Talbot Mackenzie & Associates

Re: Proposed subdivision at 1322 Rockland Avenue.

Re: Proposed subdivision at 1322 Rockland Avenue.

A1.03

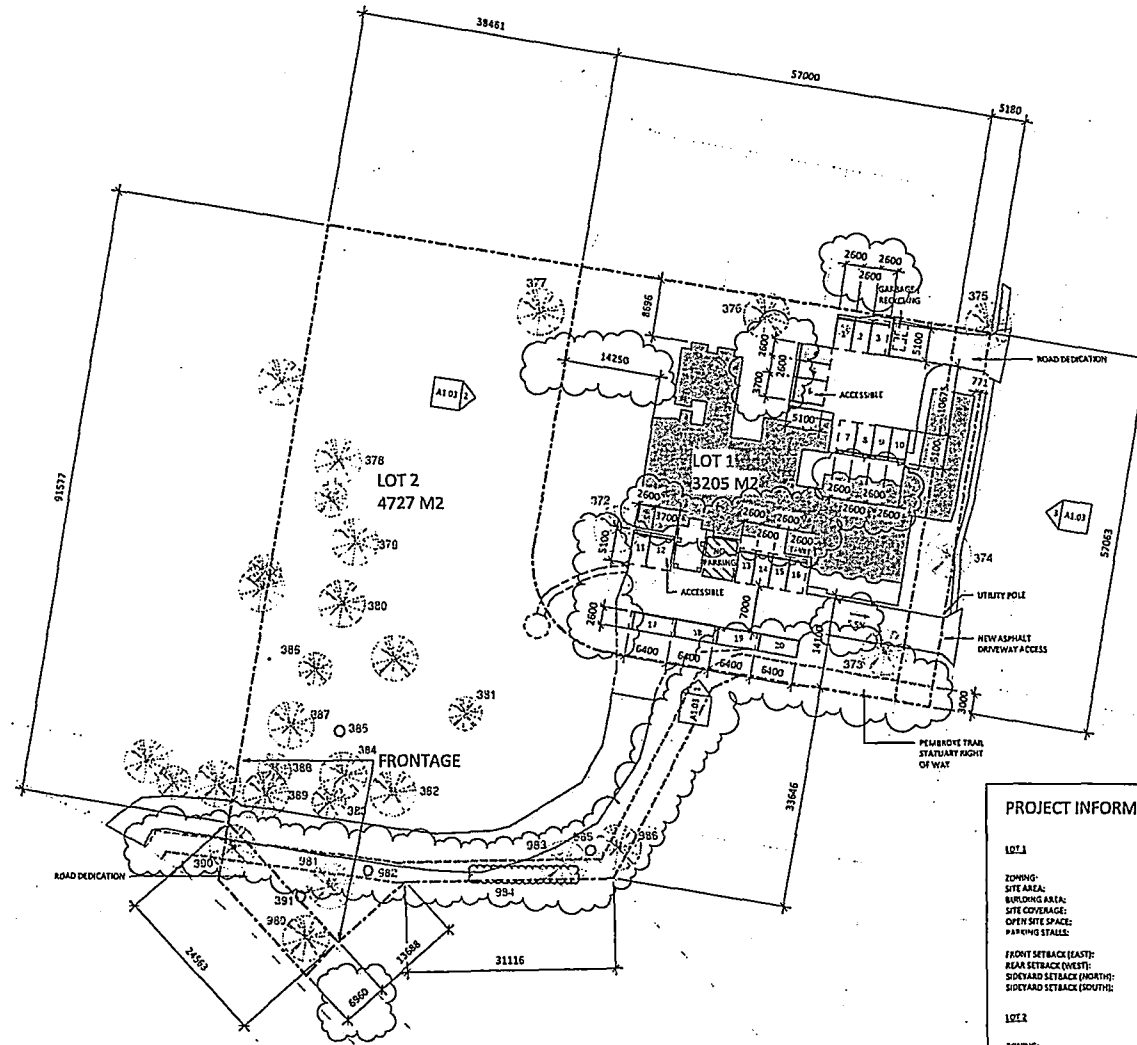
Proposed New Driveway off Royal Terrace: On the plans provided, the driveway is shown within the critical root zone of Gary Oak number 373 and it may be necessary to remove the tree. If the tree is to be retained the driveway will have to be constructed using floating permeable techniques. Once more details are made available and we have a better understanding of the fill that will be necessary, we can provide a potential design that will allow for air and water exchange to the critical root zone of the tree.

Tree retention: At this time there is no proposed building envelope, house design or services shown on the plans provided. The ability to retain trees on proposed Lot 2 will depend on the house designs, the amount of necessary blasting, the servicing details and in some cases the existing health and structure of the trees. Once more detailed plans are available, we can further comment on the ability to retain these trees and provide a comprehensive tree retention and construction damage mitigation plan for the project.

A1.03

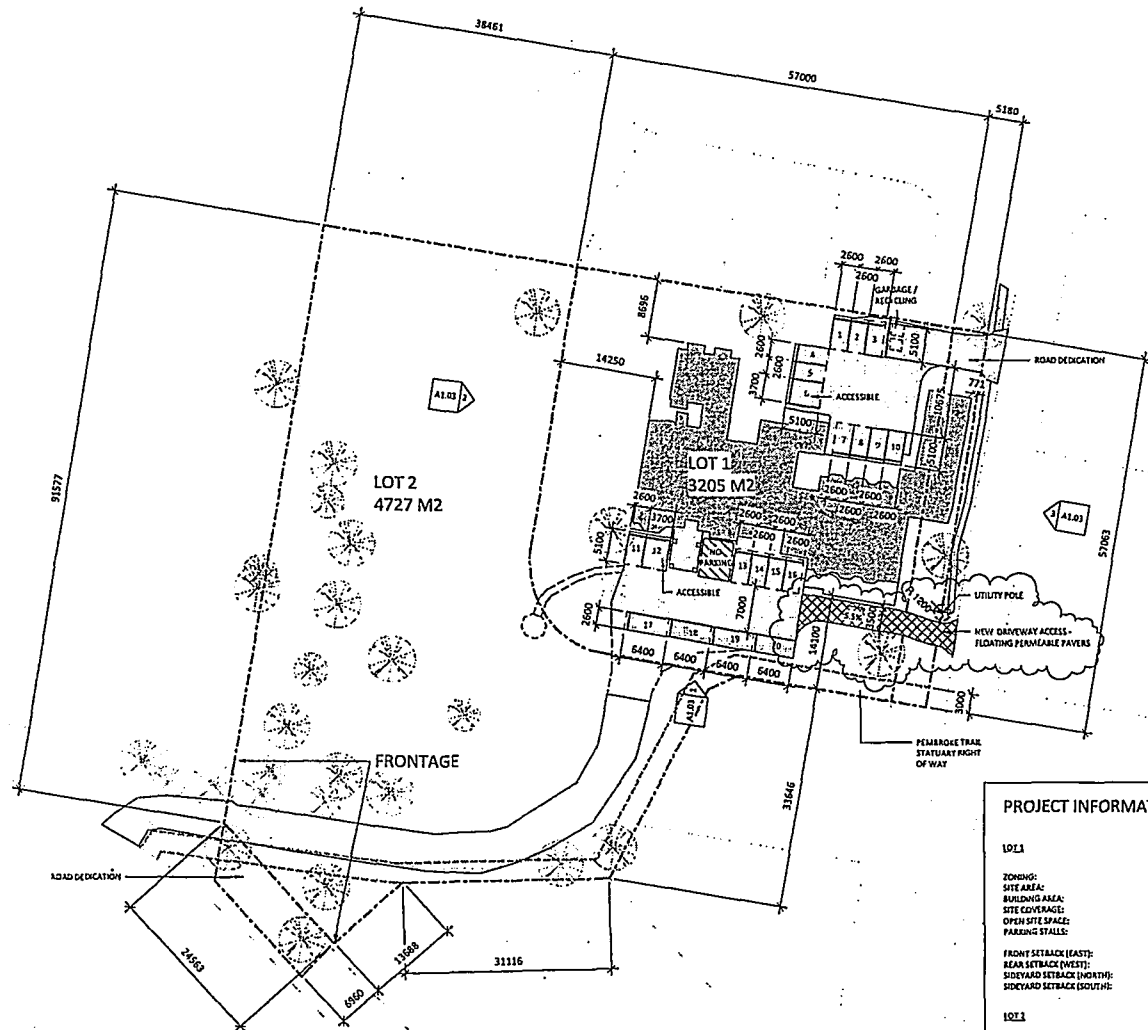
Assignment: To review the location of the proposed new driveway off Royal Terrace (see attached site plan) and provide recommendations for mitigating any potential impacts to Garry oak number 373.

Observations: The majority of the proposed driveway will be located within an area that has had a retaining wall installed, fill soil added and a laurel hedge planted (see attached sketch 1). There will be a portion of the driveway nearest the road that will be installed where there is no existing retaining wall.

Although no exploratory excavations were completed behind the retaining wall, we anticipate the wall was likely installed due to shallow soils and existing rock as a means to provide a suitable planting area for the hedge. Due to the previous soil disturbance and retaining wall installation in this area, we do not anticipate the proposed new driveway will have any negative impact on the health or stability of the tree beyond the impacts that may have already occurred historically providing the driveway is installed using the following specifications.

The amount of fill soil that can be removed without encountering roots from the oak tree will dictate the final design of the new driveway. We recommend using the following floating driveway specifications to minimize any impacts the proposed new driveway may have on Garry oak 373. We do not anticipate that any significant roots will be encountered from Garry oak 374.

Recommendations: We recommend that any excavation for the proposed driveway be completed under the direction of the project arborist and may involve a combination of digging by hand and small machine excavation. This will include the removal of any portions of rock wall that must be removed and the removal of the existing laurel hedge. If any roots from Garry oak 373 are encountered during the excavation the proposed new driveway must be designed to retain them.

There is a portion of the proposed new driveway that will be constructed on municipal property in the road dedication area. If during the excavation, significant roots are encountered that cannot be pruned without negatively impacting the tree, we recommend that floating permeable construction techniques be incorporated, if permitted by the City.
